**SUBJECT: Samsung Electronics Co., Ltd.
FCC ID: A3LCLP310N
Class II Permissive Change
Orig. Grant Date: January 4, 2008**

Transmitted herewith is an application for a Class II Permissive Change Certification of the Color Laser Printer.

BEFORE	AFTER
Main controller board	Memory type change	DDR1 (rev 0.1)	DDR2 (rev 0.3)

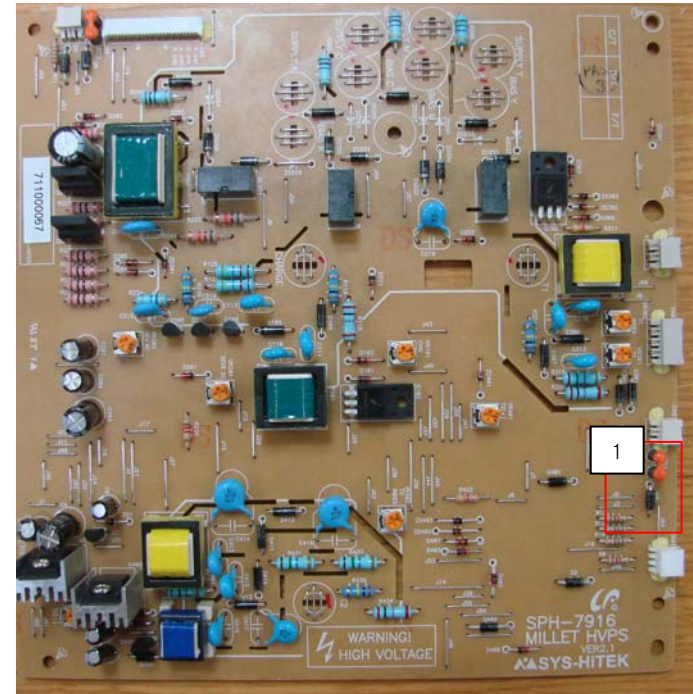
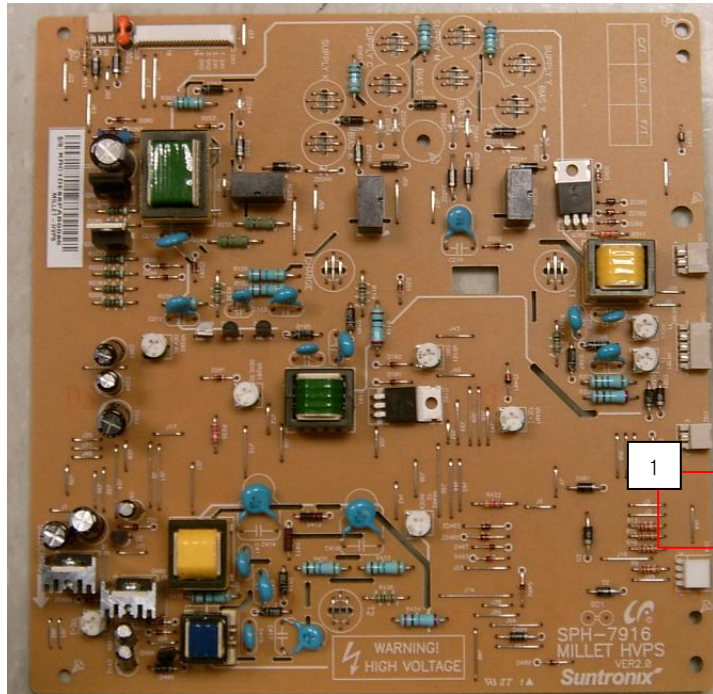
1. Upgraded Main controller board: Rev 0.1 => Rev 0.3 (change for memory type).
2. Upgraded HVPS board: Rev 2.0 => Rev 2.1 (ESD improvement).
3. Additional vendors for SMPS: SungHo-Electronics.
